# UNITED STATES PATENT AND TRADEMARK OFFICE

APPLICATION NO.	FILING DATE	FIRST NAMED INVENTOR	ATTORNEY DOCKET NO.	CONFIRMATION NO.
10/662,536	09/15/2003	Jean Joseph Botti	DP-300006	2268

## Office Action Summary

FIG. 1

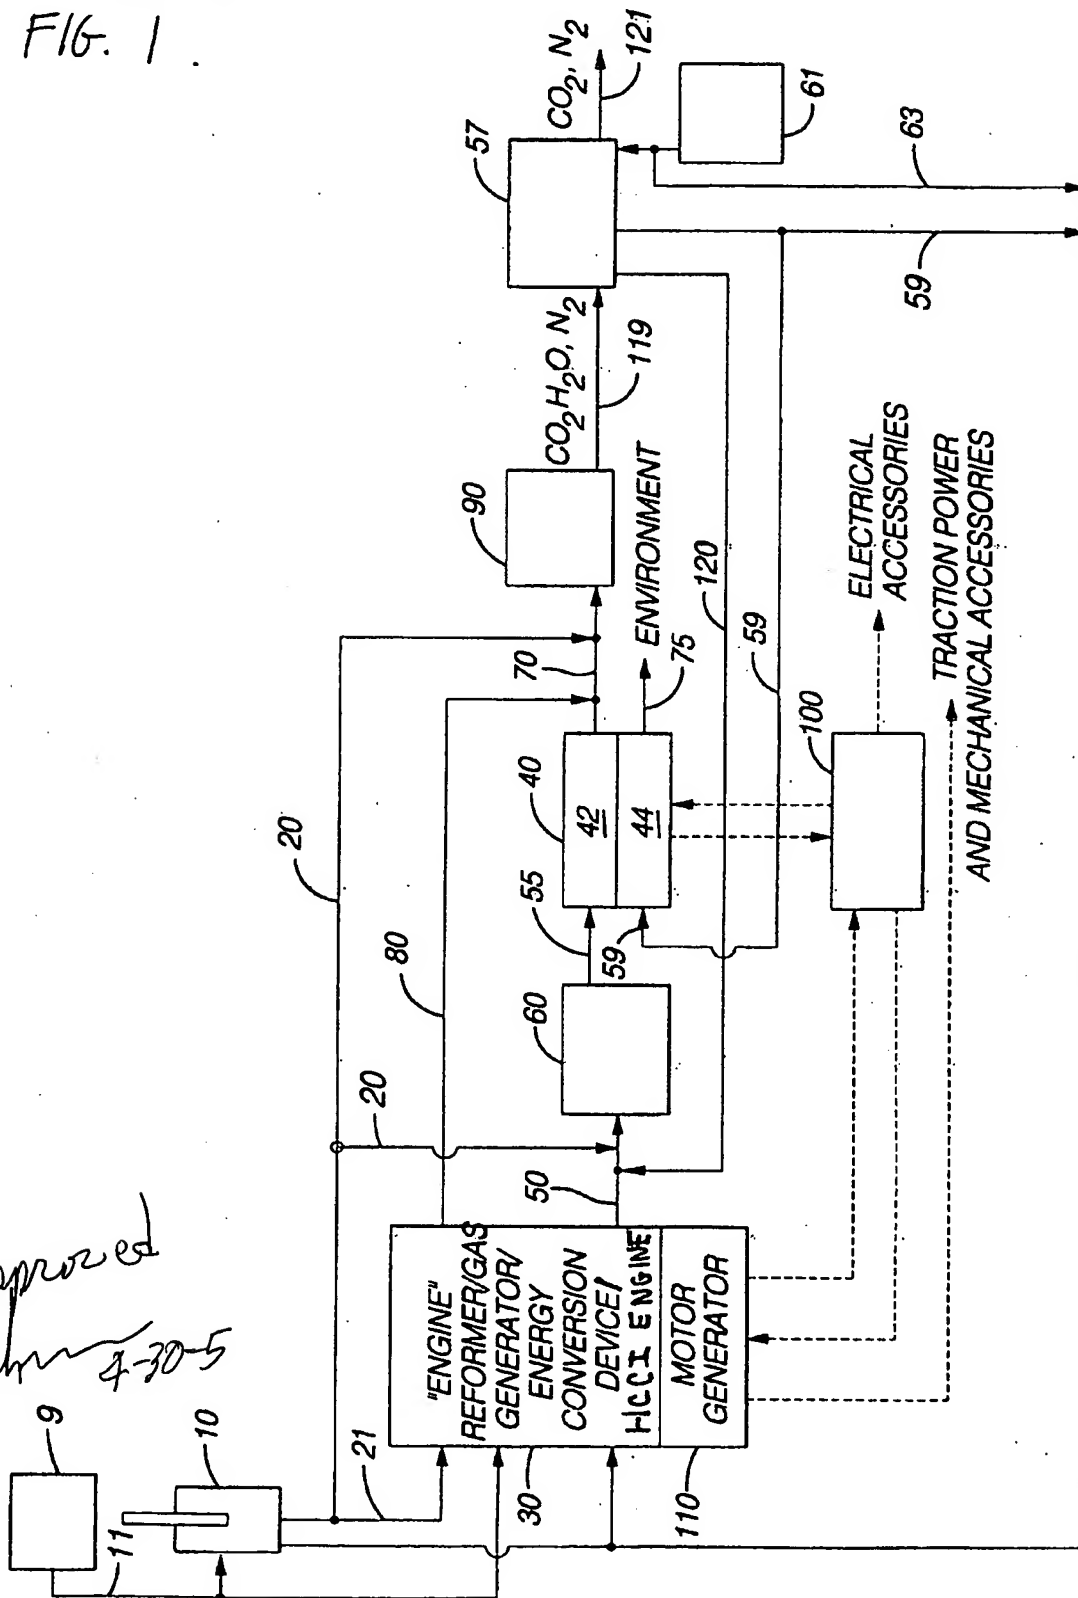
11. The drawing correction dated 3-10-2005 in which the words "/HCCI ENGINE" was added to "block 30" is not approved, as this implies block 30 as it now "reads" on Figure 1 is either an "engine reformer", "gas generator", "energy conversion device" or an "HCCI engine". As best understood from lines 1-3 of page 10, reference number 30 can be configured as any of the embodiments of Figures 2-4 and that the HCCI is an "electrical ignition" associated with Figure 2. This also leaves unclear why the abbreviation "HCCI", as noted above is best understood to be an "electrical ignition" is associated with the word "engine" as noted above.

From this, it would seem to be most clear if block 30 of Figure 1 "listed" the embodiments of Figures 2-4, and also including the "engine" of Figure 1, and that the

HCCI were shown on Figure 2. Again note, as mentioned above, that there seems to be some confusion where Figure 4 is actually located in Figure 1. Also, adding the HCCI in Figure 2 at a specific location may result in a new matter objection, unless support can be found for this HCCI location in the original disclosure. Regarding Figures 5 and 6, these Figures are best understood to be "oxygen enrichment devices" that may optionally be used with the embodiments of Figures 2-4, particularly Figure 3. Applicant may want to consider showing these devices "upstream" of reference number 30 in Figure 1 for clarity.

26. The drawing objections made on the last Office Action have been repeated on this Office Action, as for most part, the Applicant did not address the drawing objections in the amendment dated 03-10-2005. The drawing amendment dated 03-10-2005 to amend Figure 1 to overcome one drawing objection made on the last Office action was not approved for reasons set forth on this Office Action.

not approved  
By *[Signature]* 4-30-5
